RECEIVED JUL 16 1985  
 CK'D BY GSK OK'D BY \_\_\_\_\_  
 RESUBMIT APPROVED \_\_\_\_\_  
 BY DATE 7/18/85

DRAWN BY: MR	DATE: 7-10-85	CHECKED BY: MZ	SHEET NO. 4 OF 4
2-RAIL BOX BEAM BRIDGE RAIL DETAILS US RTE 4 OVER DORR DR. & OTER CREEK TOWNS OF RUTLAND & WEST RUTLAND STATE OF VERMONT PROJECT # F-EGL-F-020-1 (10) GENERAL CONTRACTOR MASKELL BROTHERS FENCE CO. FABRICATOR O.W. HUBBELL & SONS INC.			
			DS6227

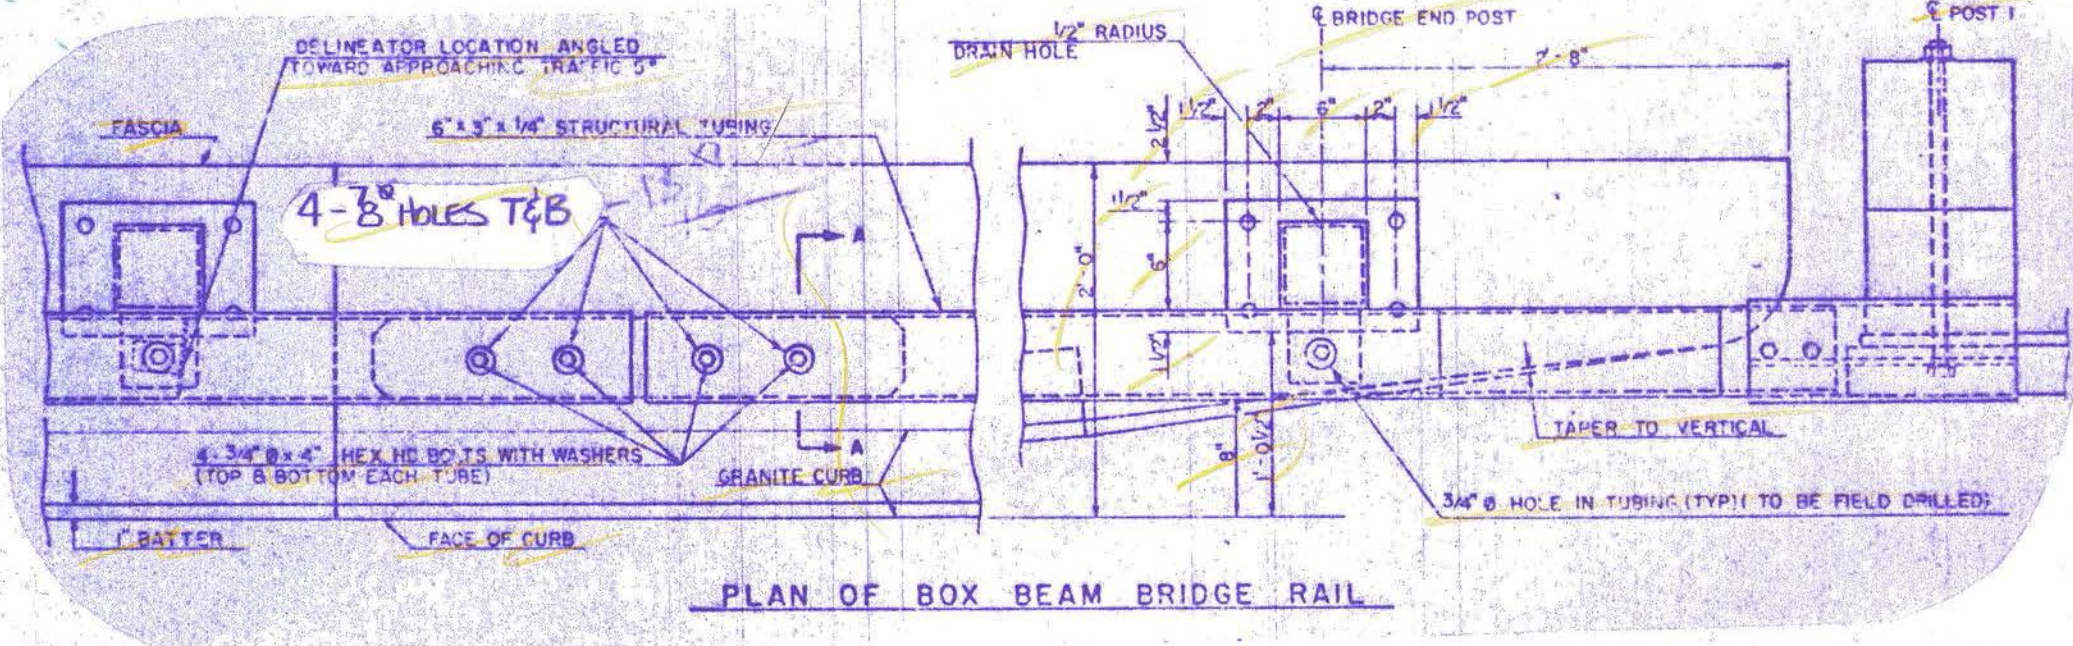
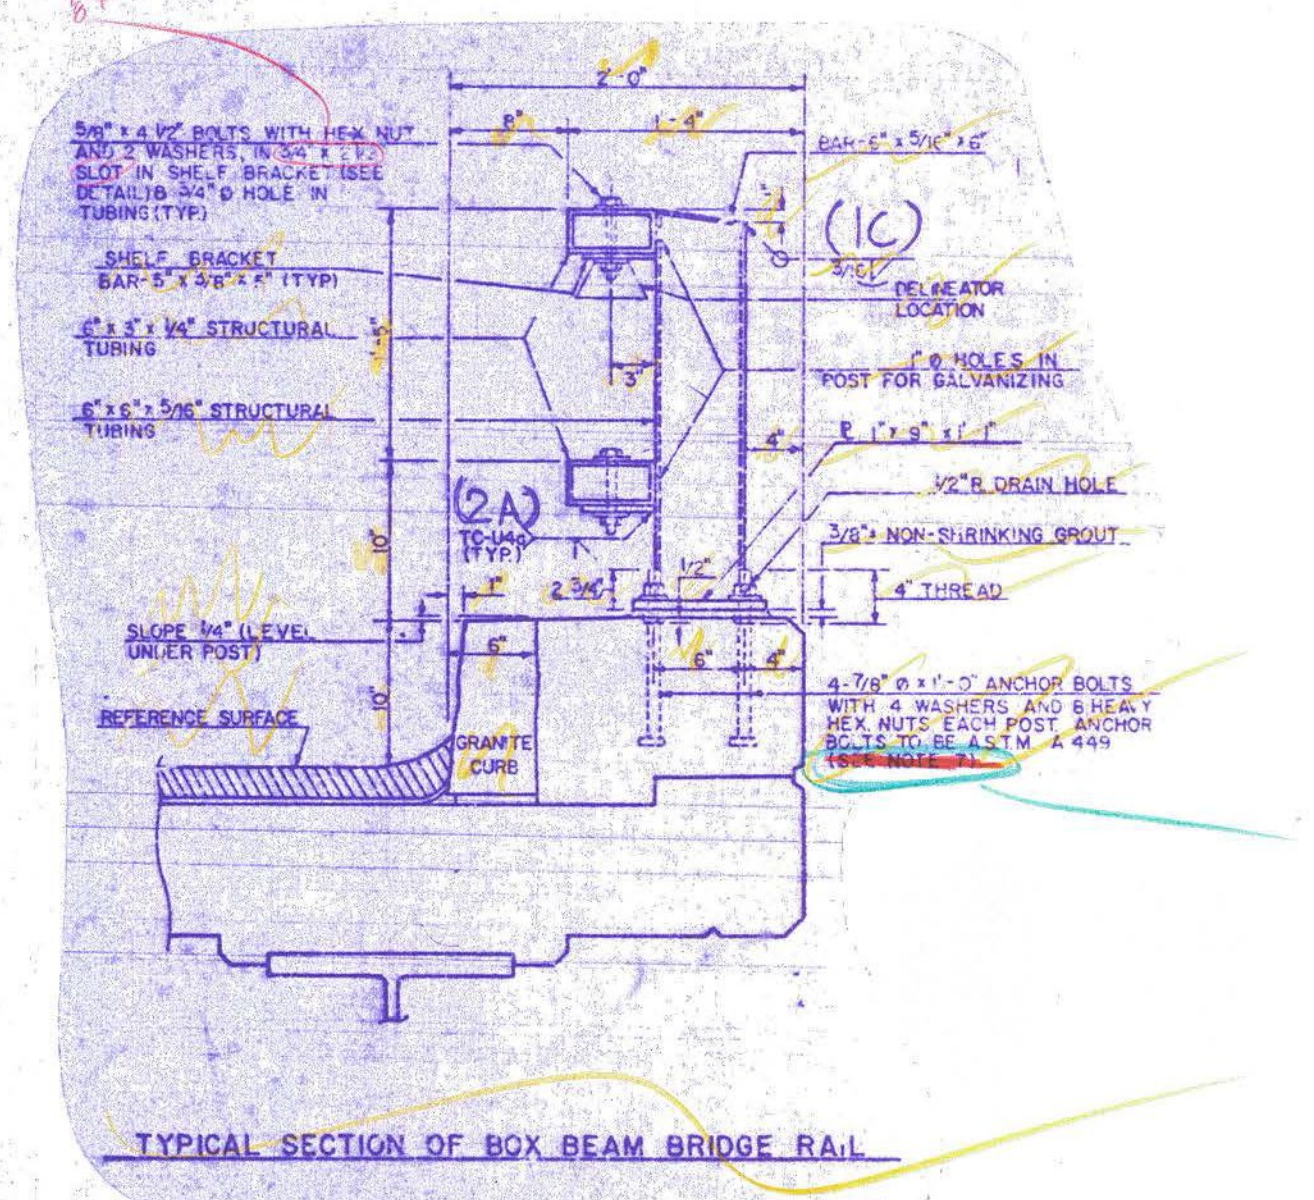
DRAWING DETAILS?
